DESIGN REVIEW - 1760 NW 56th STREET

1760 NW 56th St, Seattle, Washington  
DPD Project #3012436

BALLARD INVESTMENT PARTNERS, LLC  
ANKROM MOISAN ASSOCIATED ARCHITECTS  
June 05, 2012

## DESIGN GUIDANCE THEME 3: Ground Level Design and Landscaping

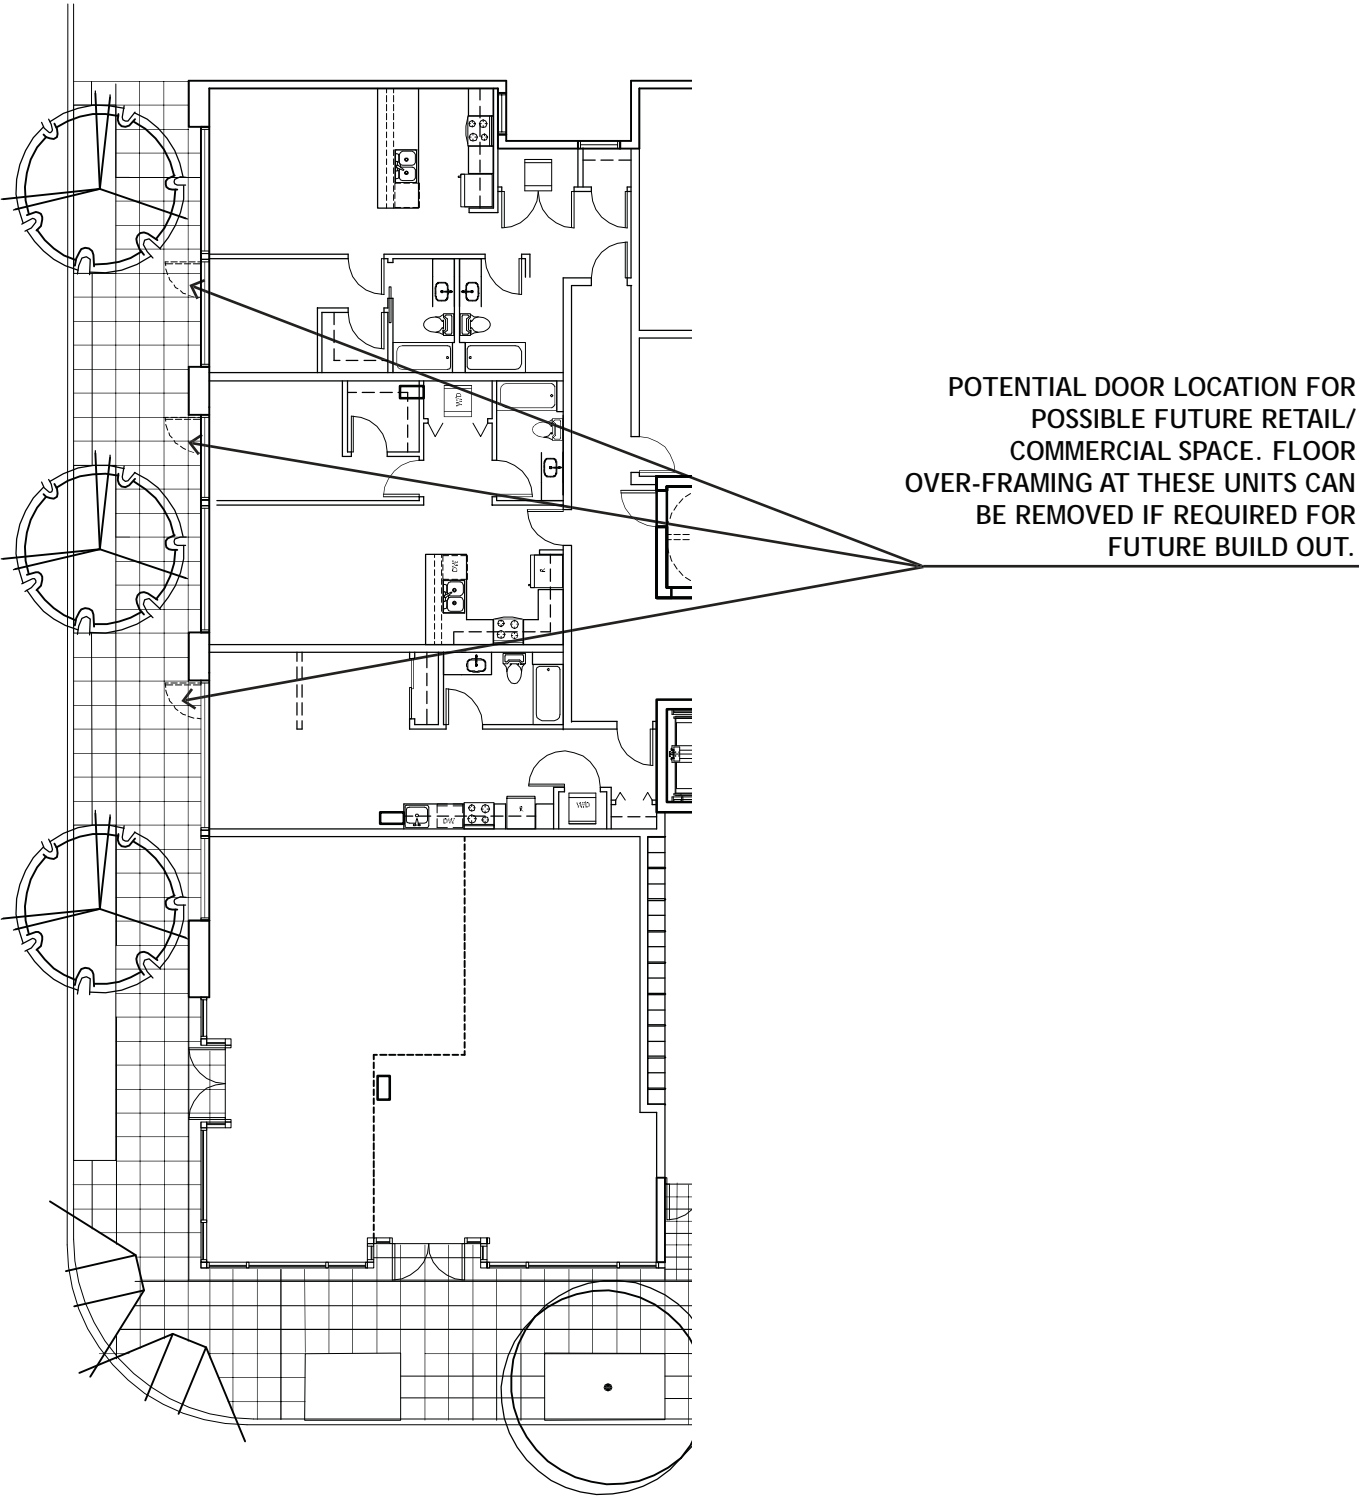
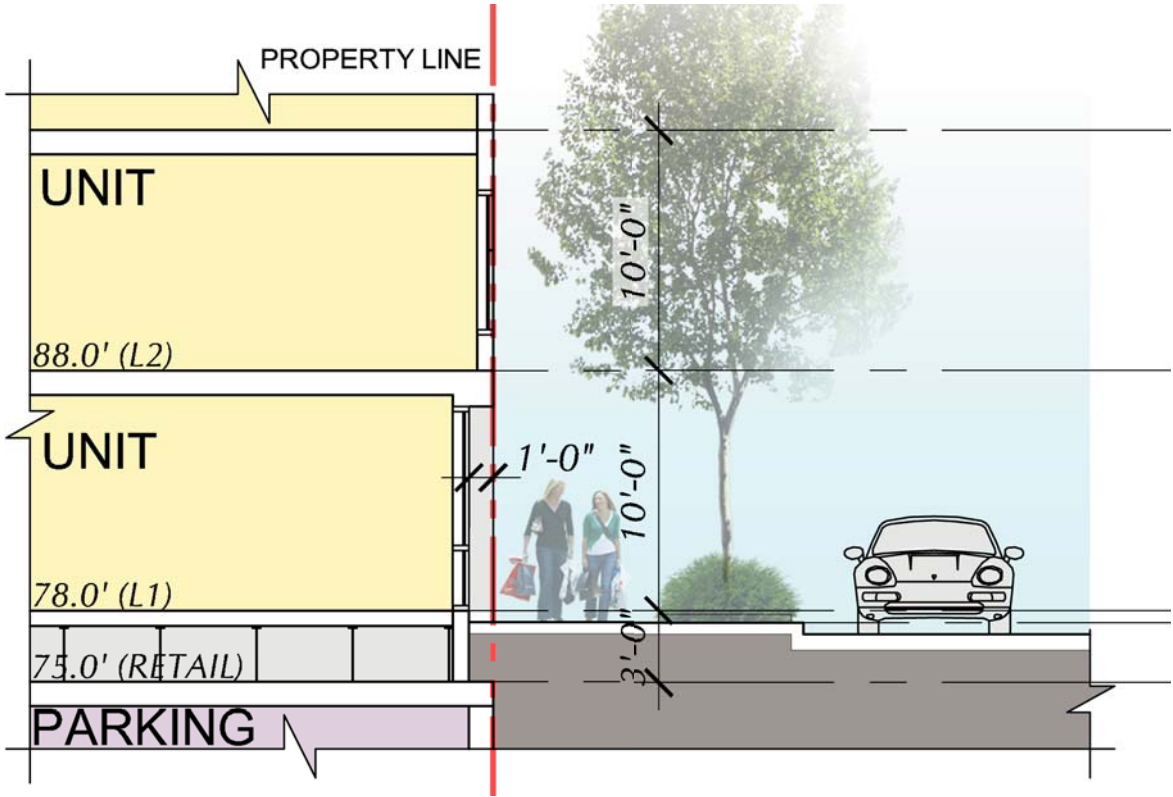
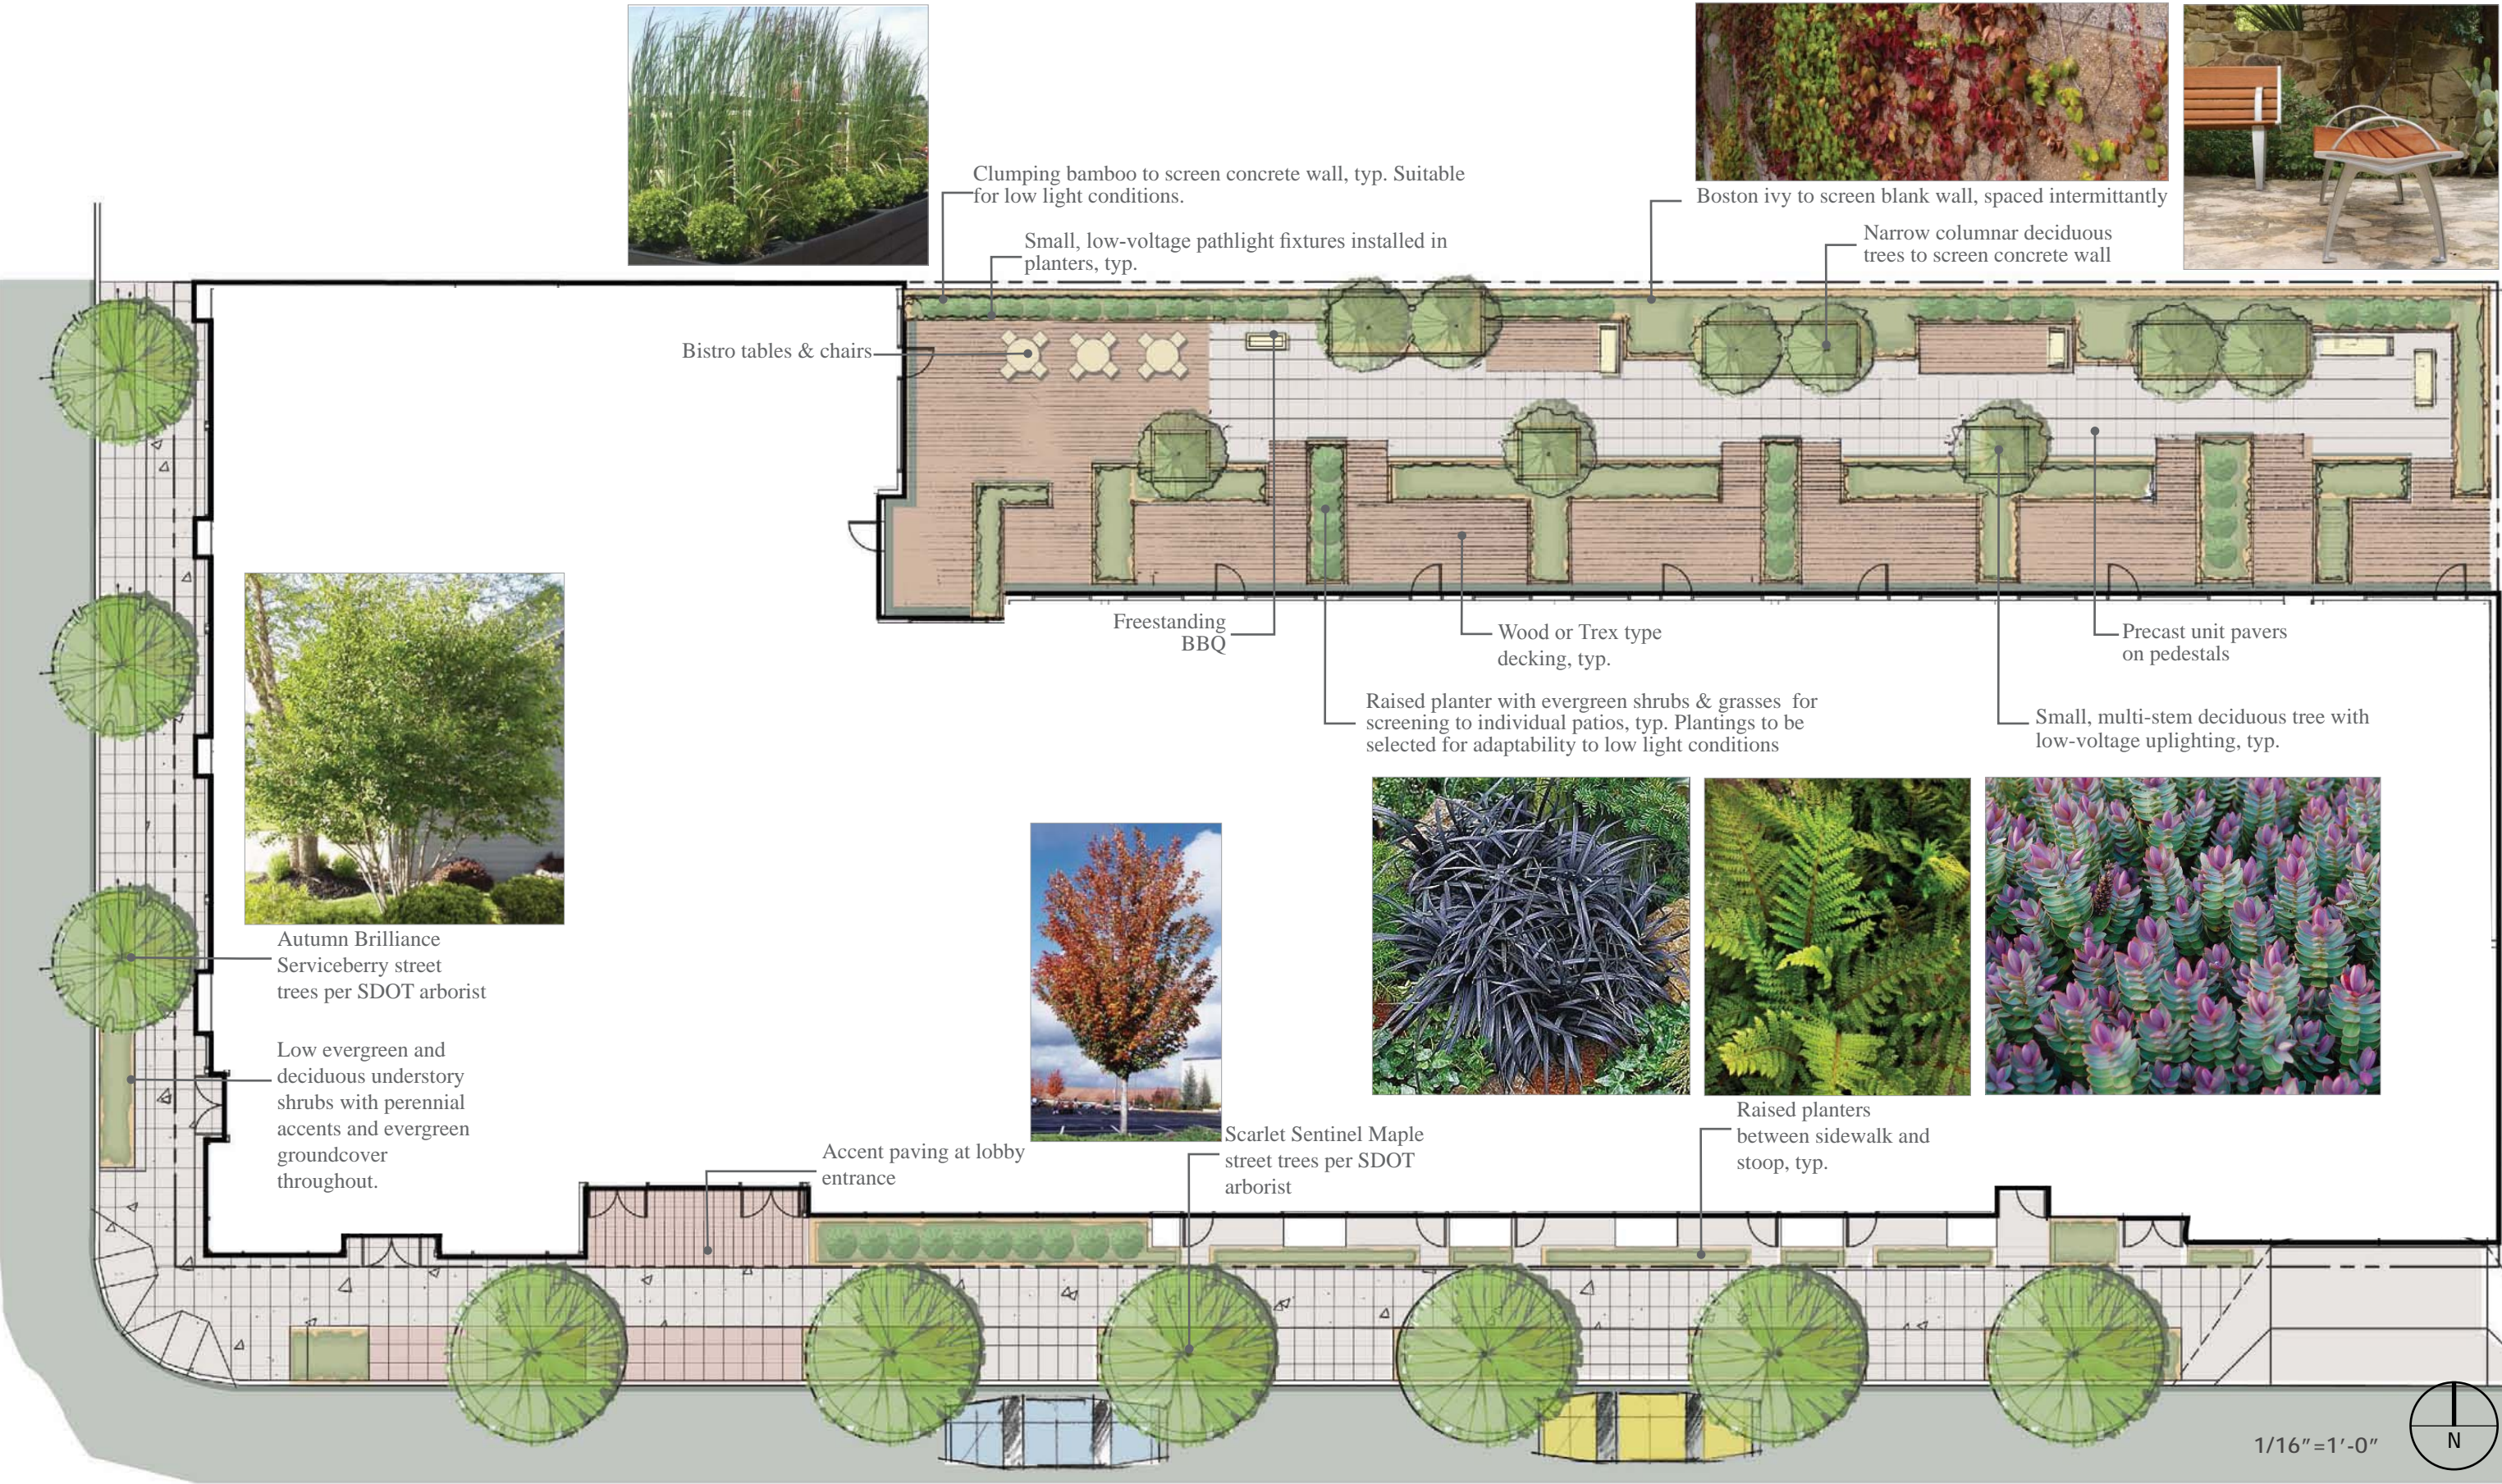
*" . . the Board supported hybrid commercial and residential expression at the ground level."*

*" If the units continue to be elevated above grade . . direct connection to sidewalk."*

*" A strong landscape design (shadow garden) that activates this space and is well programmed will be critical elements . ."*

# FUTURE RETAIL ALONG 20TH

GROUND LEVEL LANDSCAPE PLAN

## DESIGN GUIDANCE THEME 4: Garbage Collection / Parking

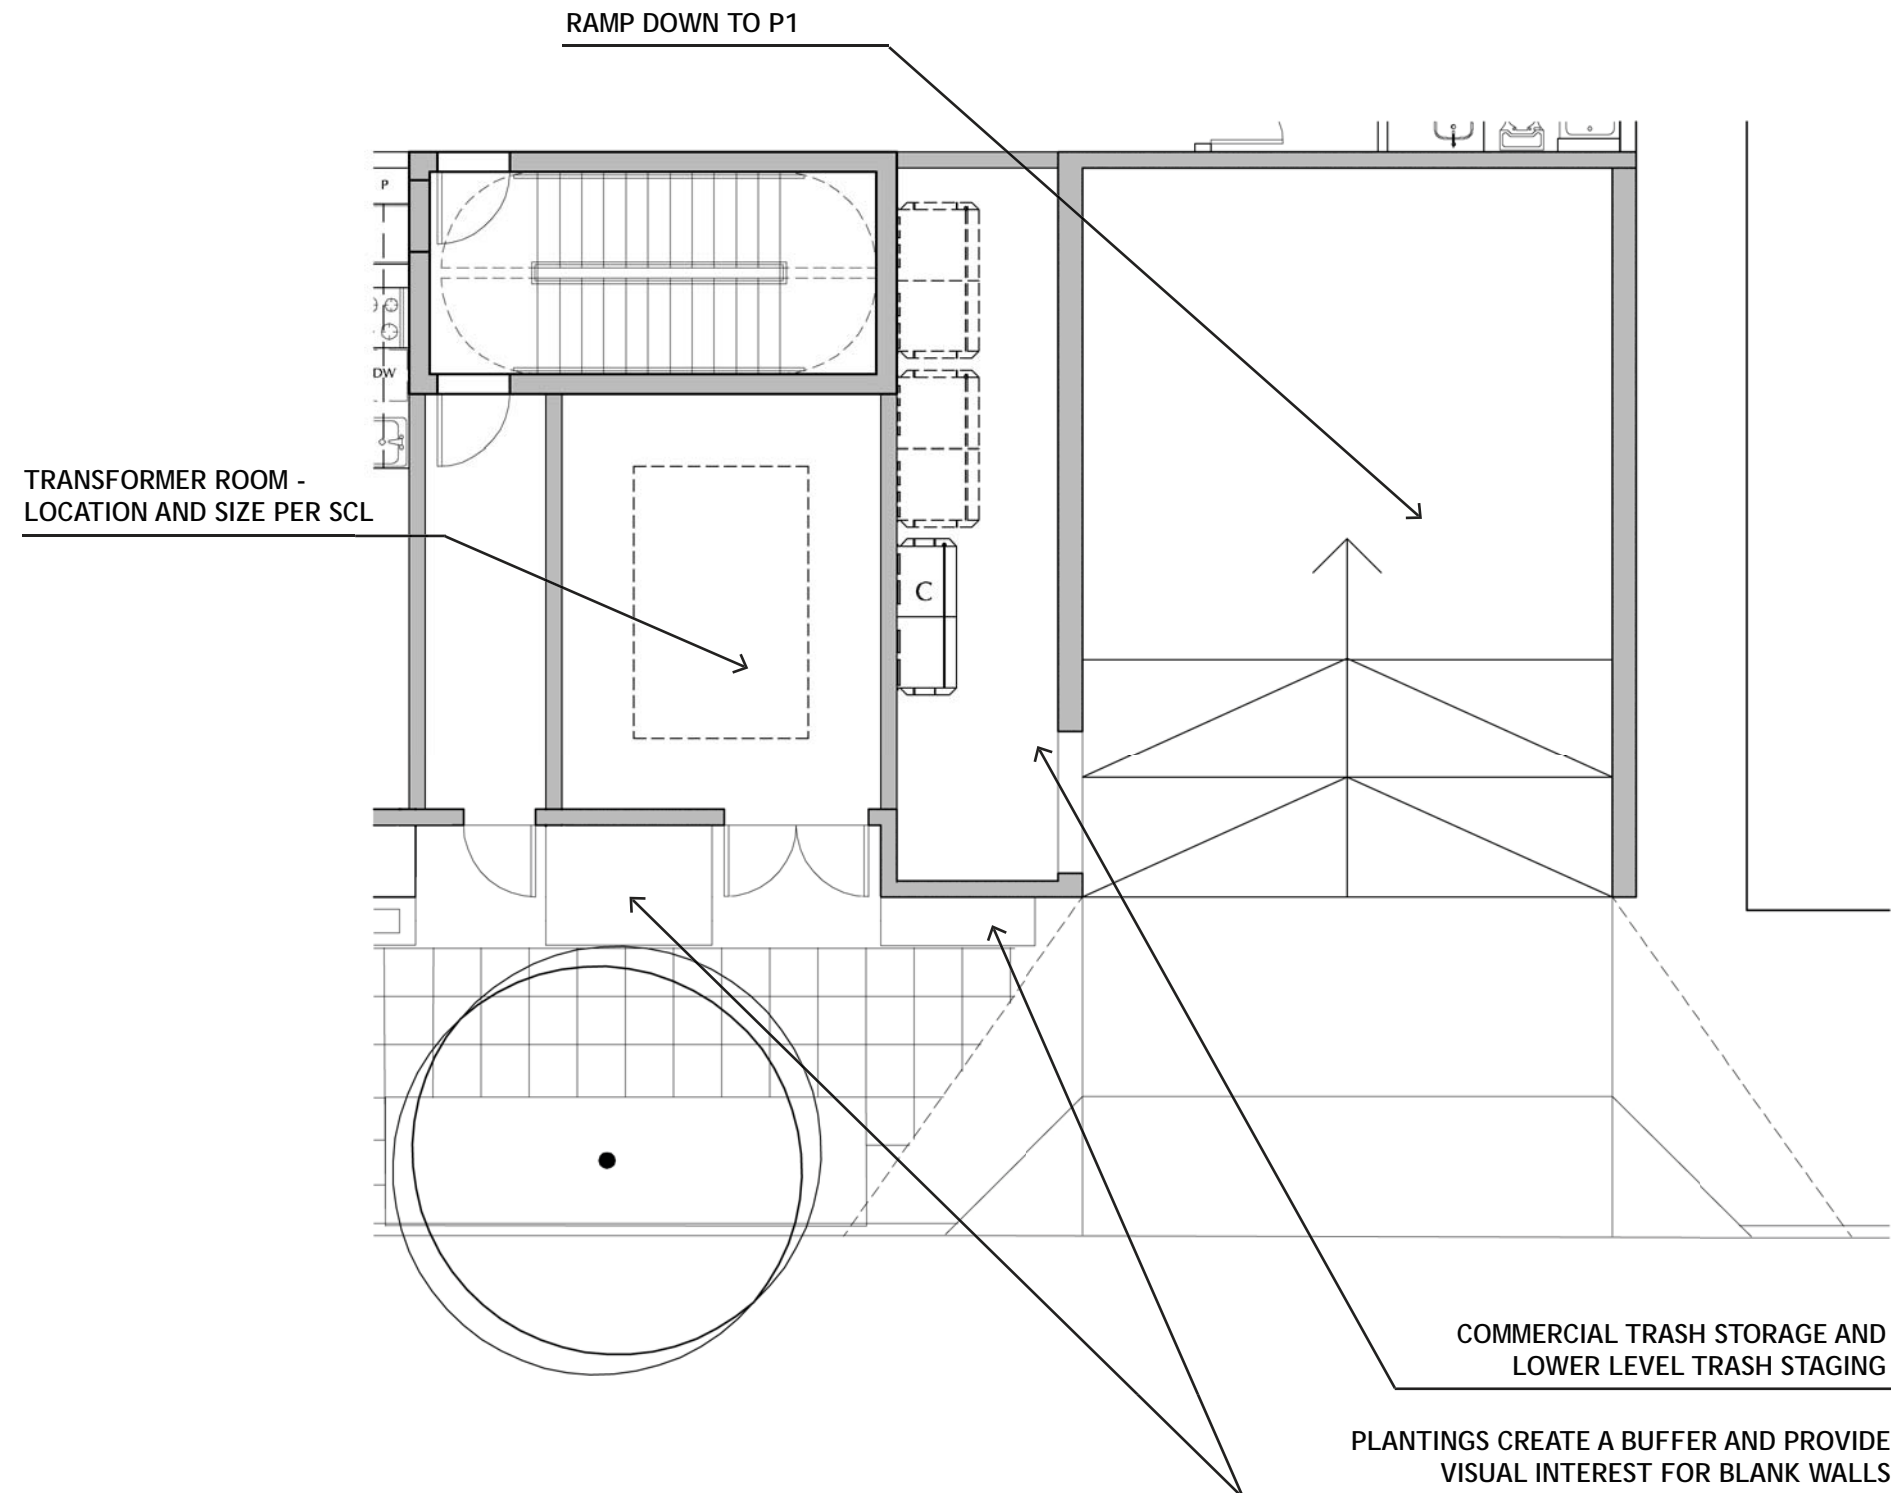
*" . . the garage entrance should be designed to be minimally intrusive to the sidewalk and pedestrian circulation."*

*" Clear sight lines and lighting should be included . ."*

# TRASH ROOM PLAN AT STREET LEVEL

LEVEL L1 - TRANSFORMER / TRASH ROOM LAYOUT
